CITY PLAN COMMISSION**THURSDAY, March 26, 2026****FILE NUMBER:** PLAT-26-000074**SENIOR PLANNER:** Hema Sharma**LOCATION:** Kristen Drive at Kolloch Drive, northwest corner**DATE FILED:** February 27, 2026**ZONING:** R-7.5(A)**CITY COUNCIL DISTRICT:** 13**SIZE OF REQUEST:** 0.8911-acres**APPLICANT/OWNER:** Zsazo LLC

REQUEST: An application to replat a 0.8911-acre (38,815-square foot) tract of land containing all of Lots 4 and 5 in City Block 4/8616 to create four lots ranging in size from 0.209-acre (9,128-square foot) to 0.262-acre (11,429-square foot) on property located on Kristen Drive at Kolloch Drive, northwest corner.

1:2,400	<p>EXISTING AREA ANALYSIS MAP</p> <ul style="list-style-type: none"> <input type="checkbox"/> Area Of Request <input type="checkbox"/> Recent History 	Case no: PLAT-26-000074 Date: 03/05/2026
--	--	---

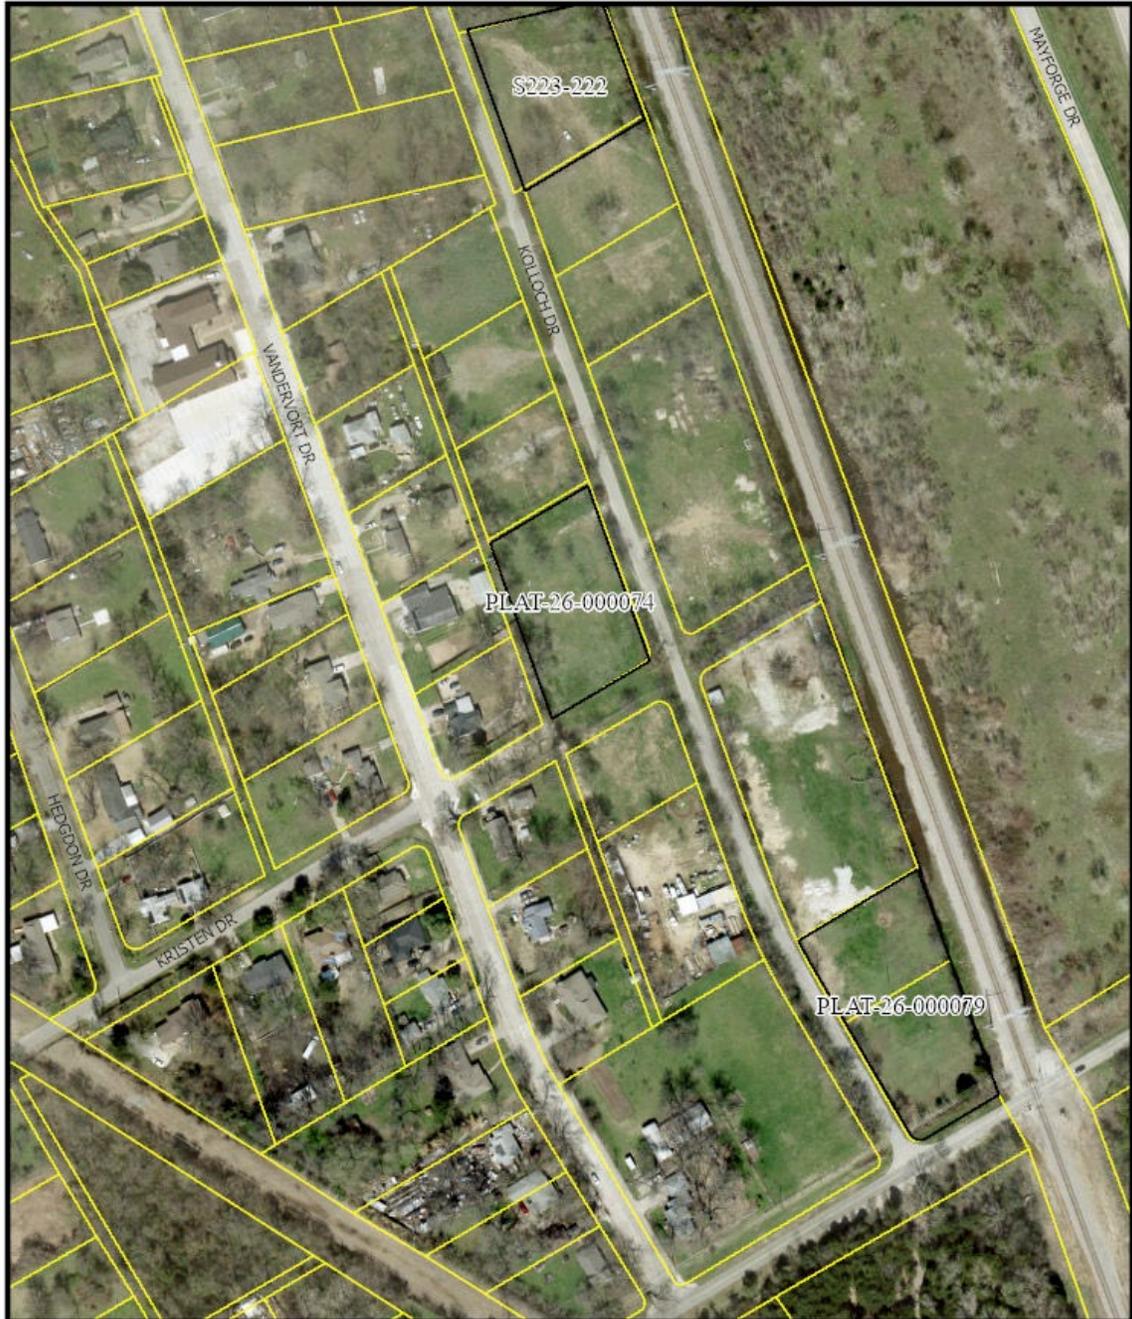
- The properties to the east line of Kolloch Drive have areas ranging in size from 9,584 square feet to 76,255 square feet and are zoned R-7.5(A) Single Family District (*Refer to the existing area analysis map*).
- The properties to the west line of Kolloch Drive have areas ranging in size from 19,679 square feet to 40,721 square feet and are zoned R-7.5(A) and R-10(A) Single Family District (*Refer to the existing area analysis map*).

Staff find that there is a variation in the lot pattern within the immediate vicinity of the request (refer to the existing analysis map and aerial map). The request complies with the zoning requirement of the R-7.5(A) Single Family District and is in compliance with Section 51A-8.503; therefore, staff recommends approval subject to compliance with the following conditions:
